SHELDON HIGH SCHOOL ROOFING 2020
C.I.P. No. 420.652.209

ROBERTSON/SHERWOOD/ARCHITECTS pc
132 E. Broadway - Suite 540
Eugene, Oregon
Project No. 1901

This Addendum forms a part of the Contract Documents and modifies the original Bid Documents dated February 24, 2020 as noted below. Acknowledge receipt of this Addendum in the space provided on the Bid Form. Failure to do so may subject Bidder to disqualification.

A1 DEMOLITION PLAN
 002 NOT TO SCALE

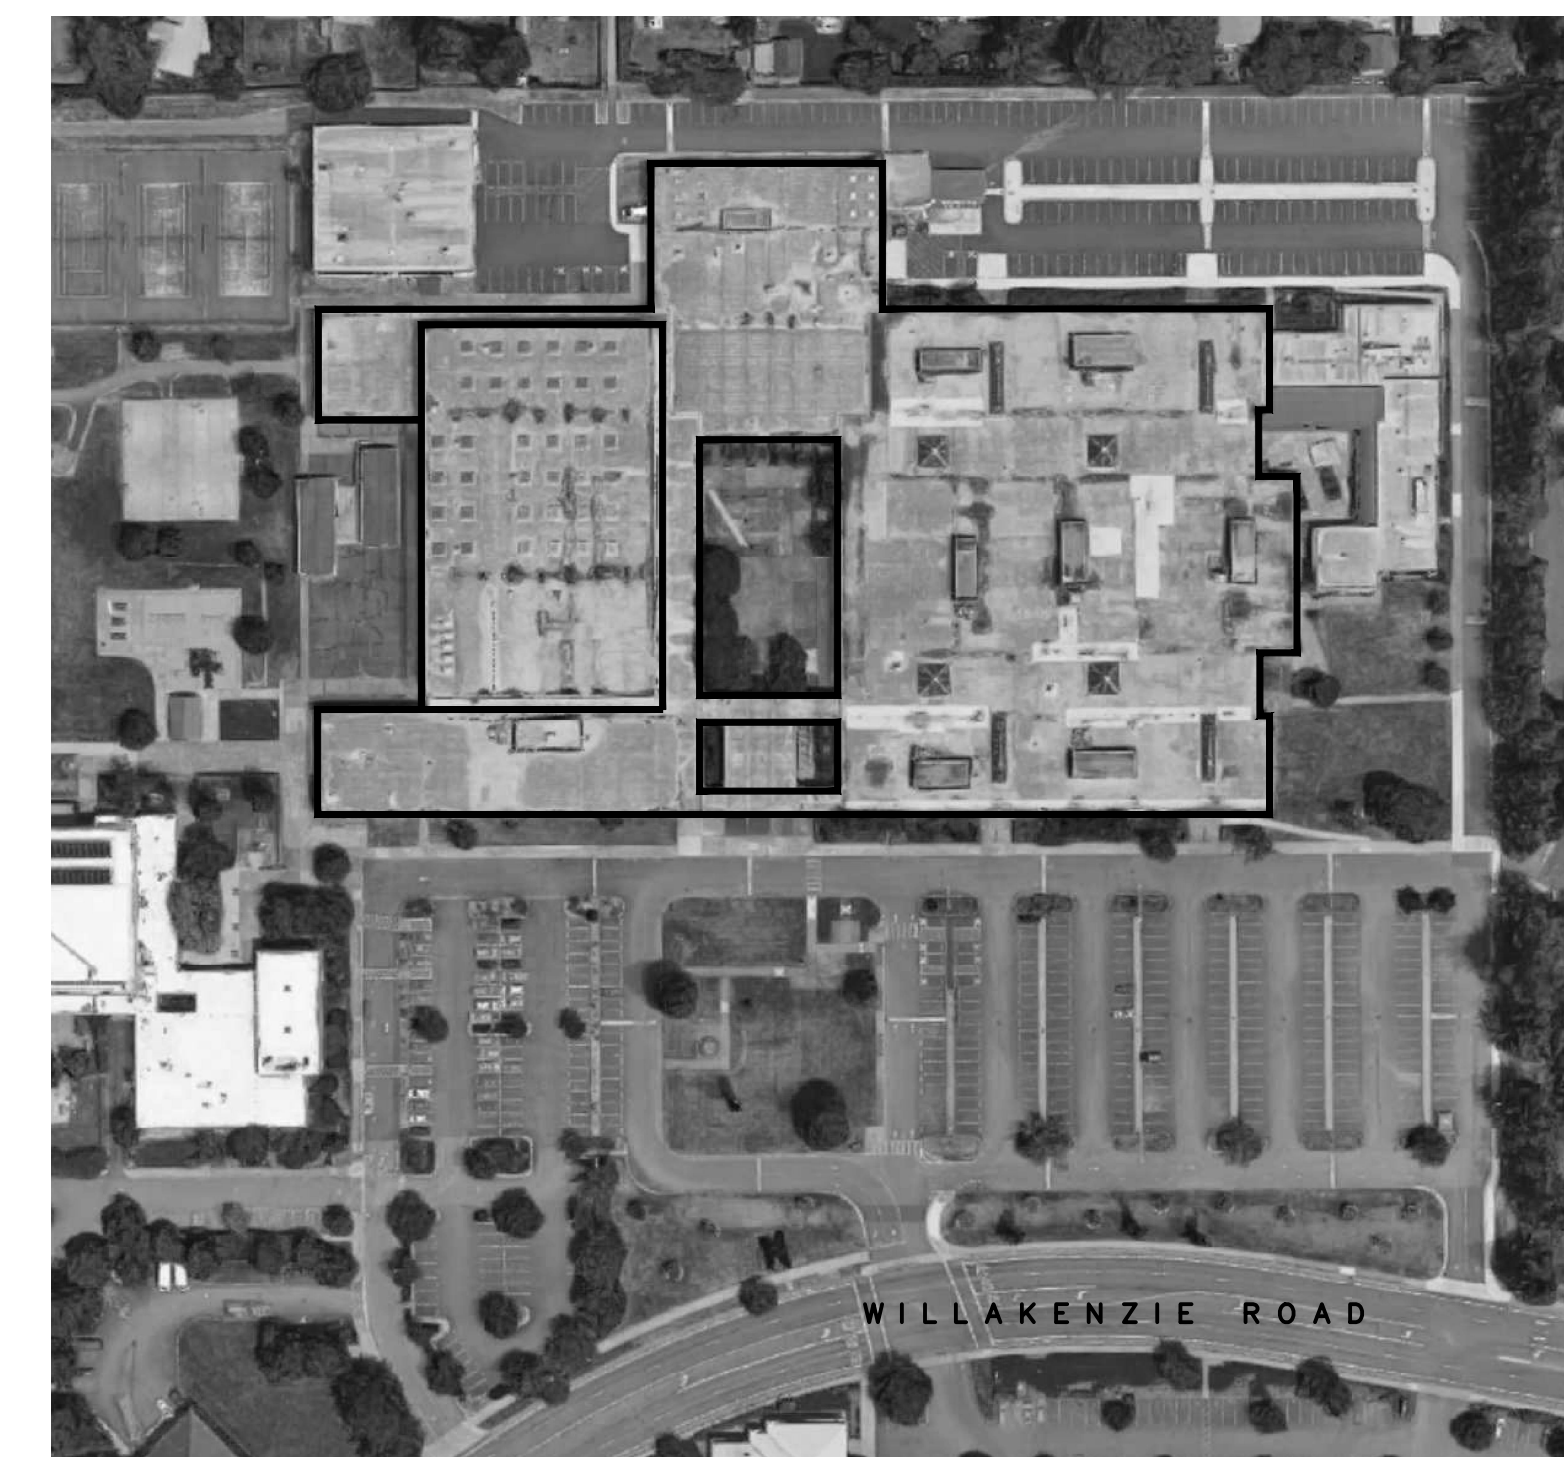
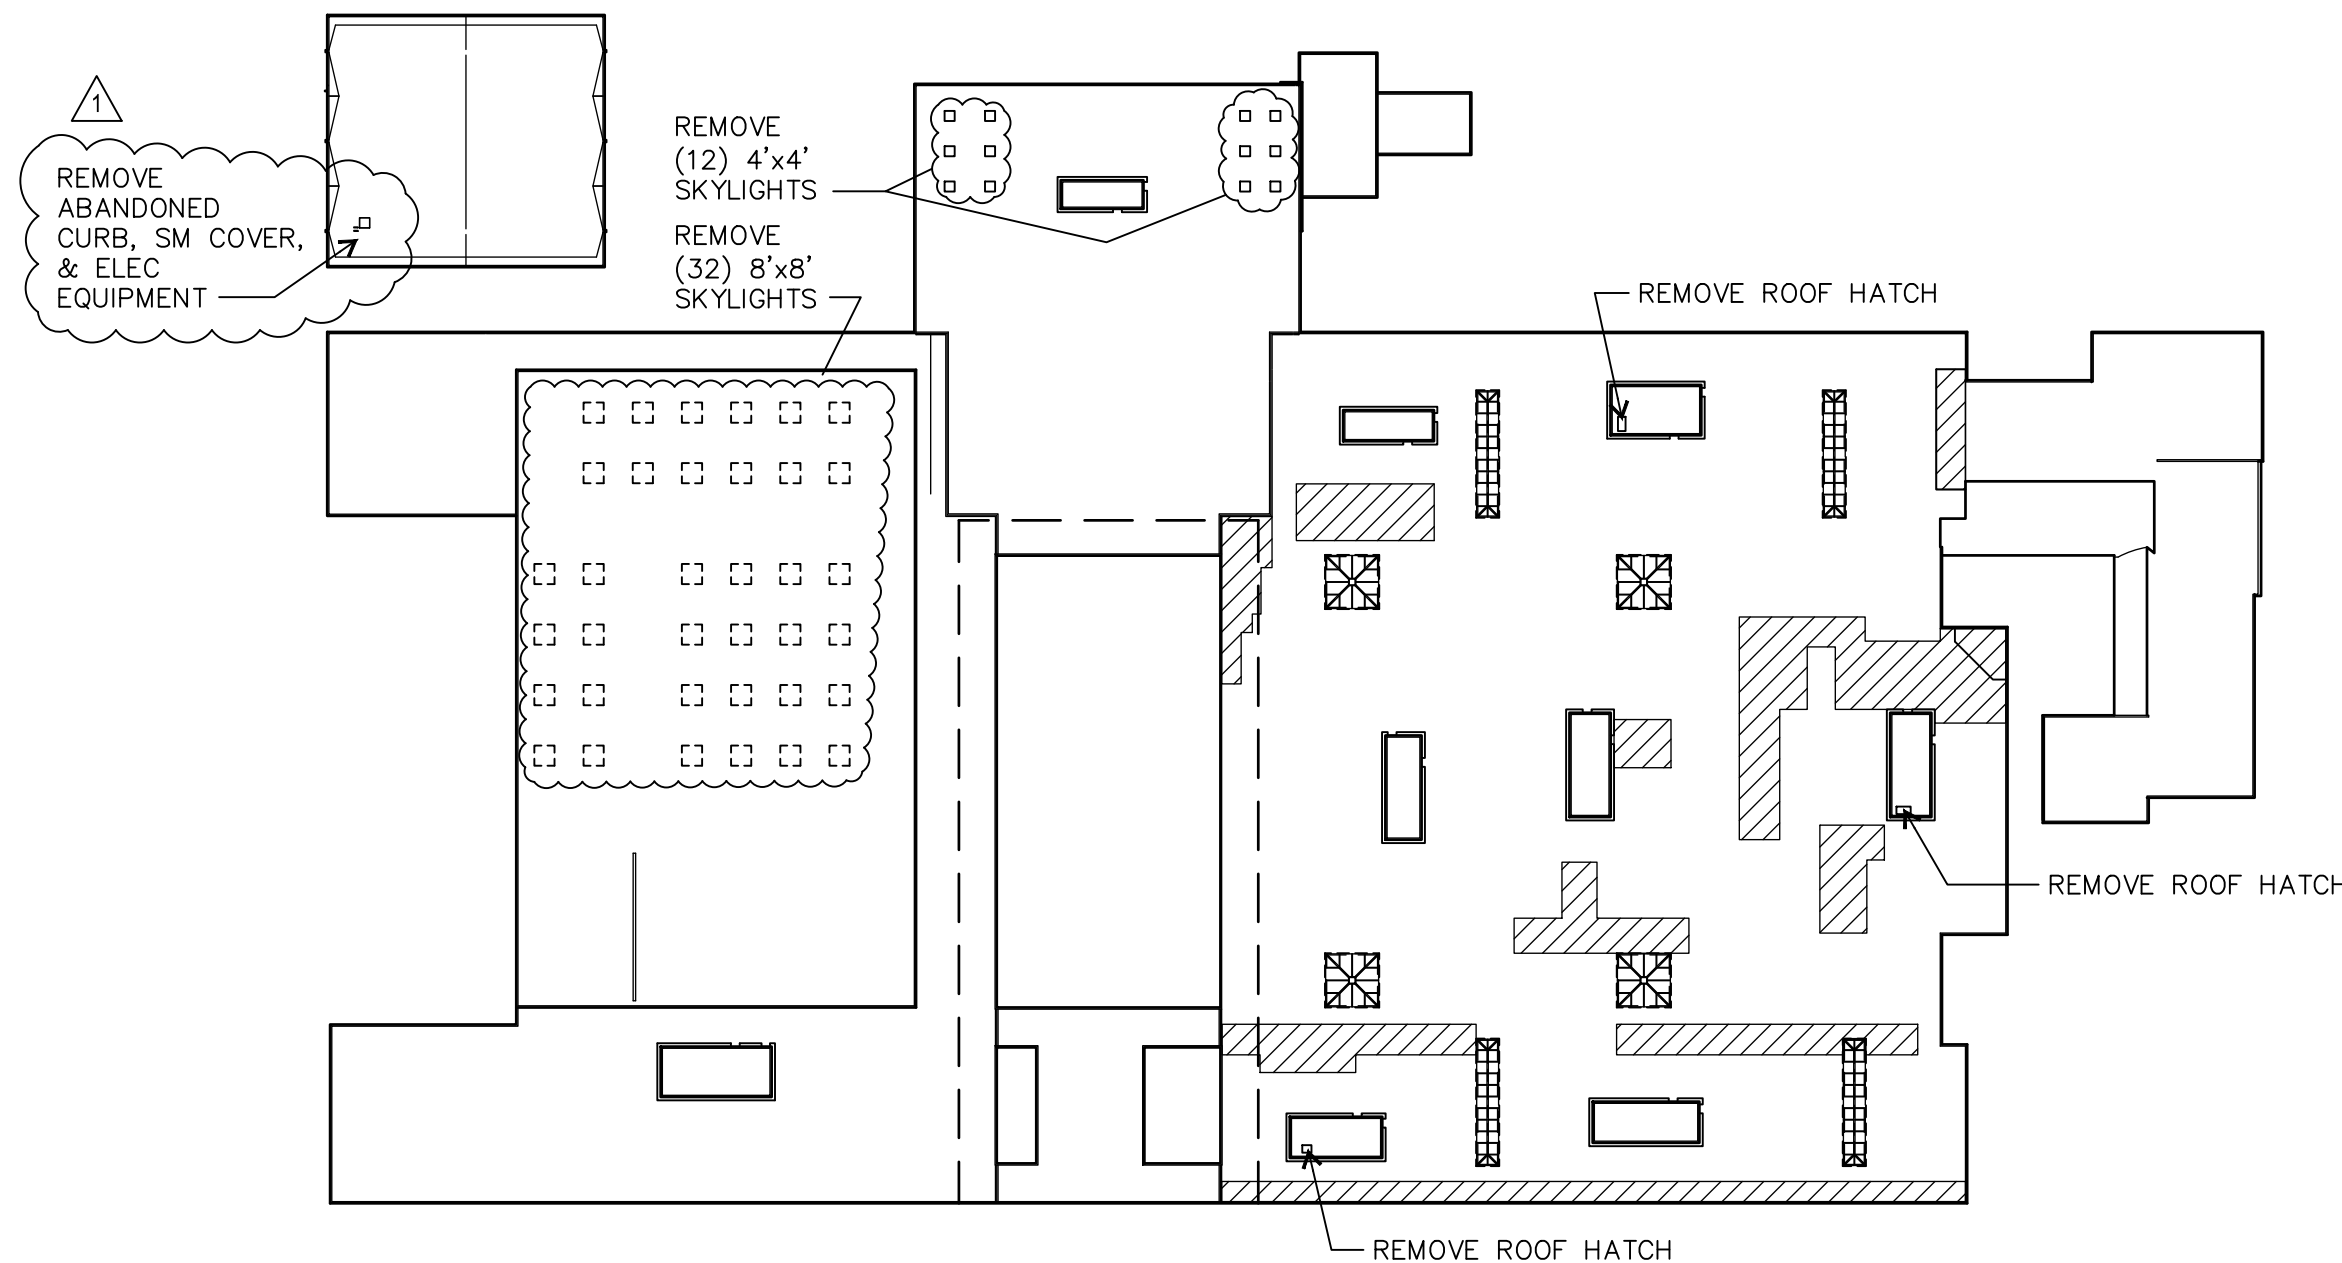
(c) Demolition Plan, A1/002: Existing roof repair overlays to be removed consist of cap sheet installed by Owner over previously existing built-up roof.
